# Review of Actions at Stauffer Chemical Company Superfund Site, Tarpon Springs, Florida

Report 2004-P-00018

SUBJECT: Ombudsman Report:  
Review of Actions at Stauffer Chemical Company  
Superfund Site, Tarpon Springs, Florida  
Report 2004-P-00018

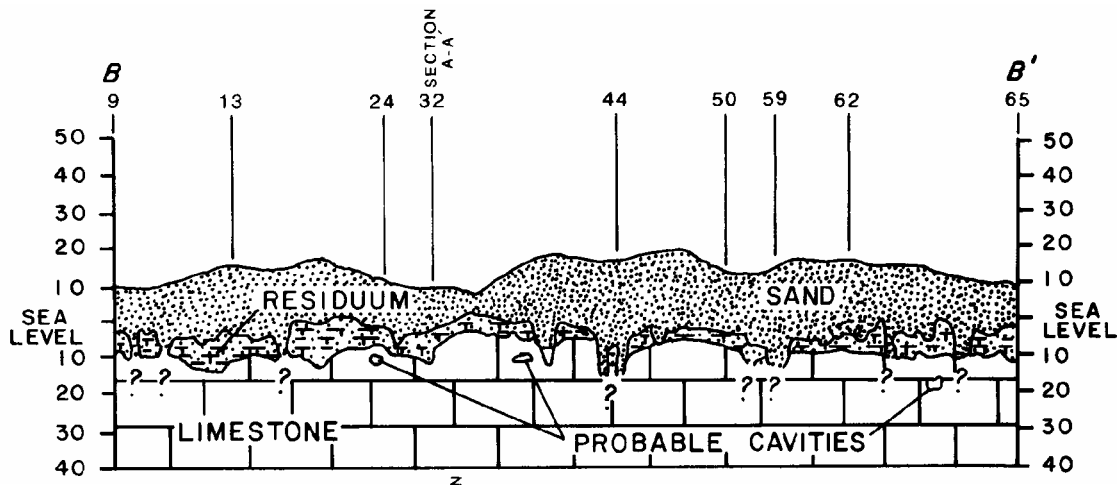
At the Stauffer site the occurrence of karst and the role of karst processes in the site hydrogeology was not mentioned in the Record until after completion of the Feasibility Study and issuance of the ROD (1998). The first reference to the karstic nature of the site appearing in the Record is Black & Veatch, 2000, which was written under contract to EPA.
